TECHNICAL MEMO

Title: Revisions to Right-of-Way Width Typical Sections Drawing

The following changes have been made to this report, sheet 2 of 22 as a supplemental drawing to Drawing NRP-D-SYSM-TY-0002-03 to reflect the current concept:

BSC TRANSPORTATION
T08-00068
SUPPLEMENT TO NRP DRAWING NRP-D-SYSW-TY-0002-03
TASK 7 - ROUTE SECTIONS AND STRUCTURES

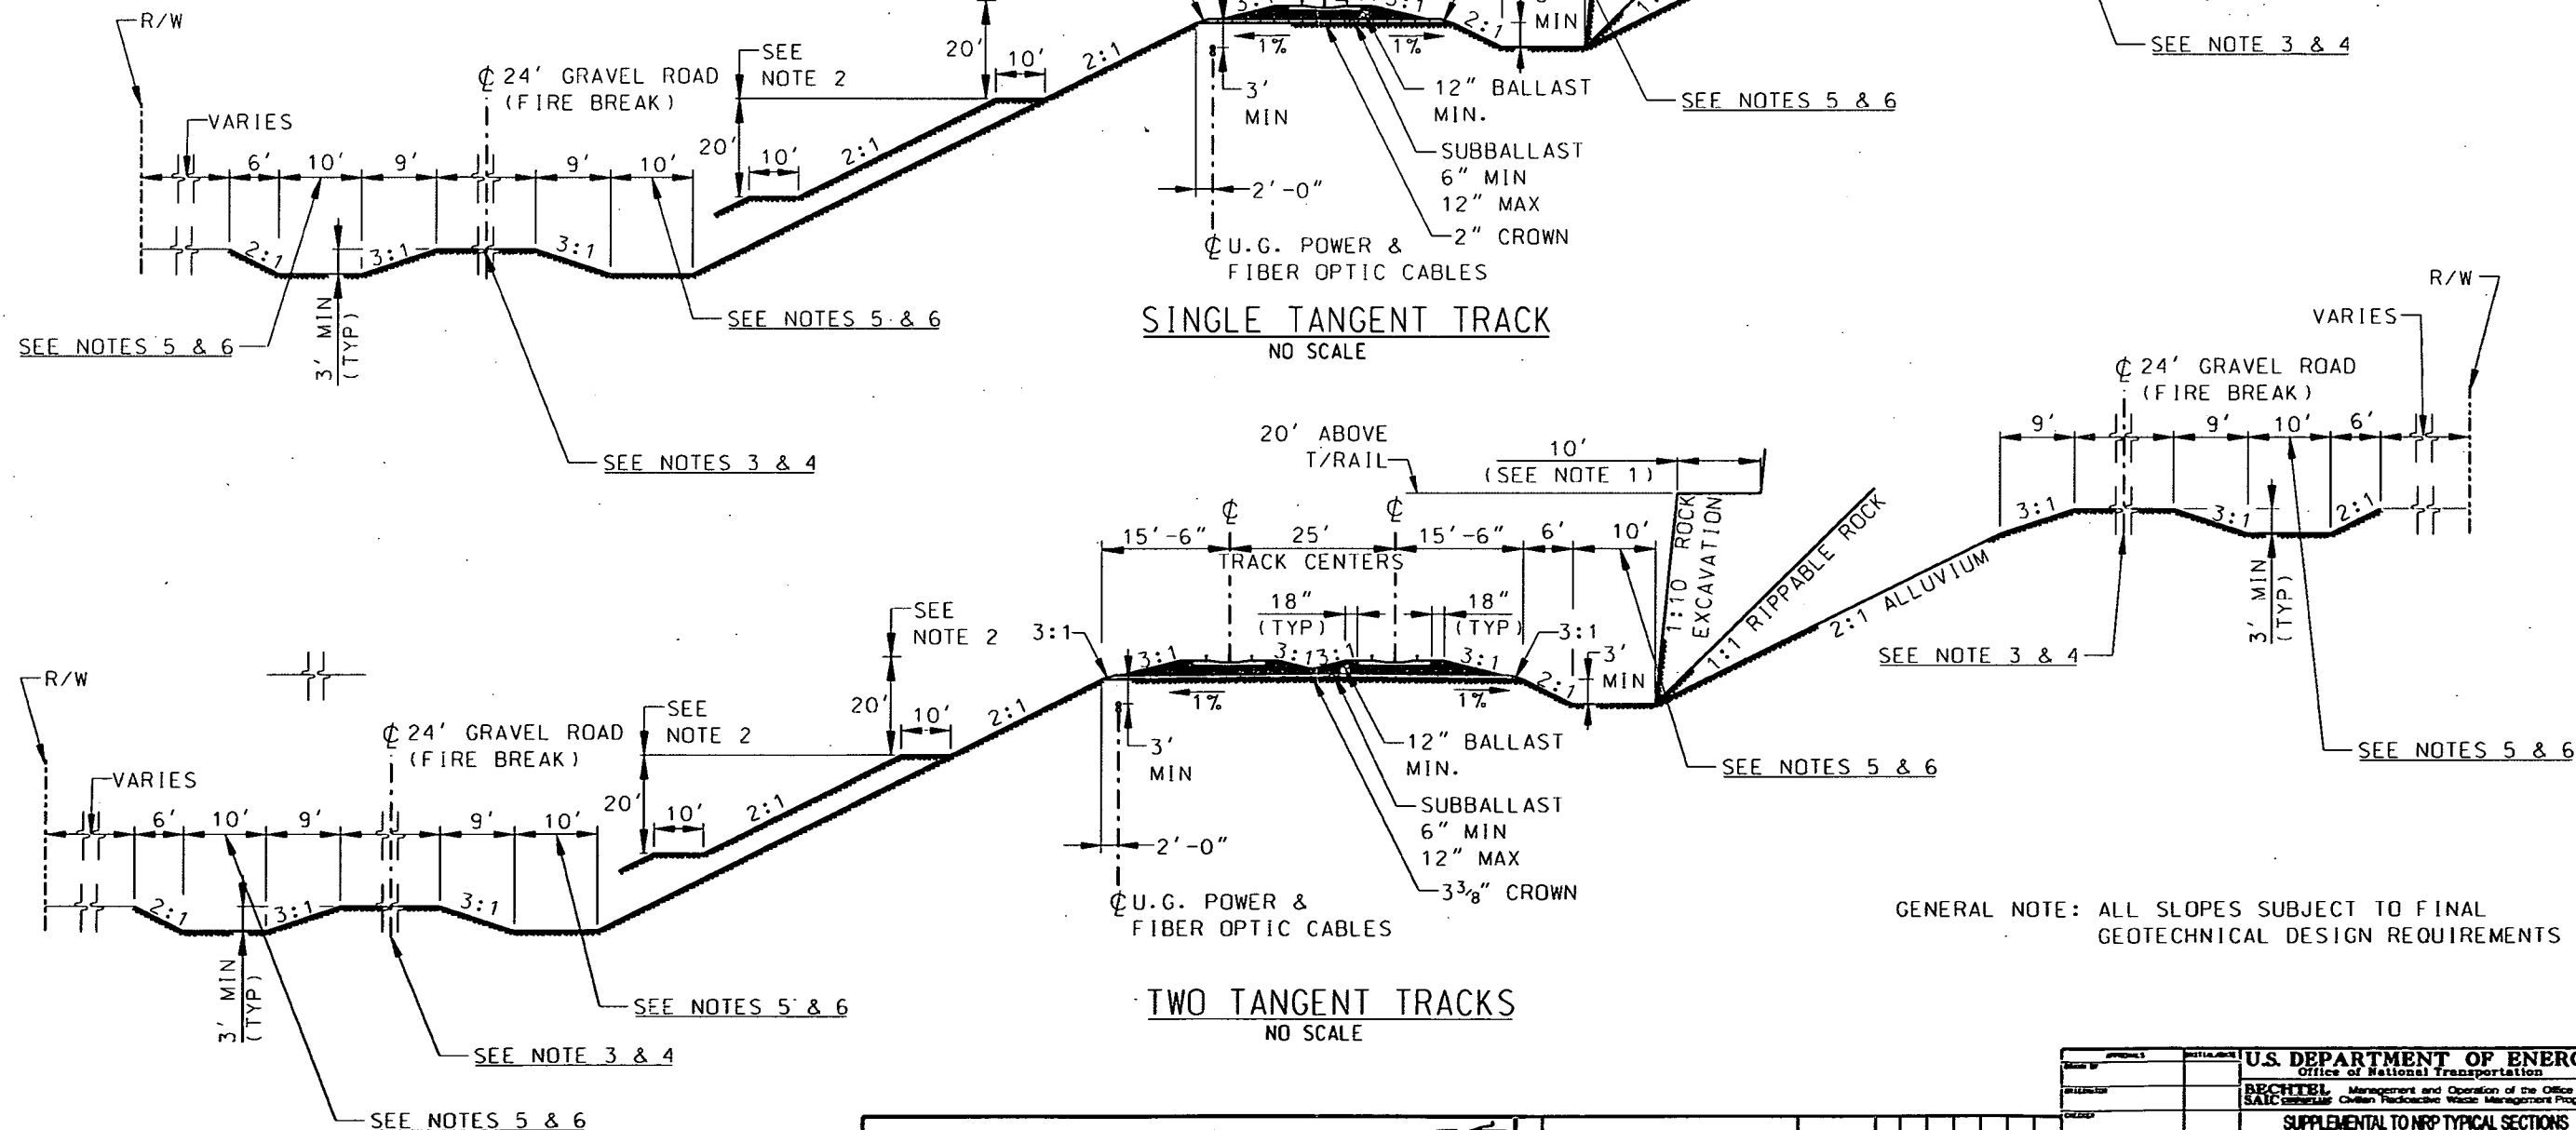
1. Changes have been made regarding service road width to allow for rail maintenance vehicles is 14' and 24' for shared-use.
2. Location of the service road will be only on one side of the railbed, and may vary due to topography and other reasons.
3. In some locations, the service road may be located at the subballast level due to drainage concerns, and space limitations.
4. The service road may be omitted in areas such as wetlands and washes.
5. Drainage ditch features shown on sheet 2 represent a maximum condition. The minimum ditch bottom is 3' wide. Ditch width may vary due to estimated quantity of surface water & may be wider to accommodate potential rock falls.
6. Ditches may not be required in areas of embankment & sidehill topography.

- ① 10' FOOT BENCH EVERY 20' IN ELEVATION ABOVE TOP OF RAIL IN ROCK CUT SECTIONS
- ② 10' FOOT BENCH EVERY 20' IN ELEVATION BELOW TOP OF RAIL IN FILL SECTIONS
- ③ GRAVEL SERVICE ROAD WIDTH WILL BE 14' WIDE FOR TRACK MAINTENANCE AND 24' WIDE FOR SHARED USE.
- ④ THE SERVICE ROAD WILL BE LOCATED ONLY ON ONE SIDE OF THE ROADBED. TOPOGRAPHY AND OTHER FACTORS WILL DETERMINE WHICH SIDE. IN SOME LOCATIONS, THE SERVICE ROAD WILL BE LOCATED AT THE SUB-BALLAST LEVEL OR FOLLOW EXISTING TOPOGRAPHY.

- ⑤ DITCH WIDTH MAY VARY DUE TO ESTIMATED QUANTITY OF SURFACE WATER & POTENTIAL ROCKFALLS. THE MINIMUM BOTTOM WIDTH IS 3'.
- ⑥ DITCHES MAY NOT BE REQUIRED IN AREAS OF EMBANKMENT & SIDEHILL TOPOGRAPHY.
- ⑦ SERVICE ROAD MAY BE OMITTED IN AREAS SUCH AS WETLANDS & WASHES.
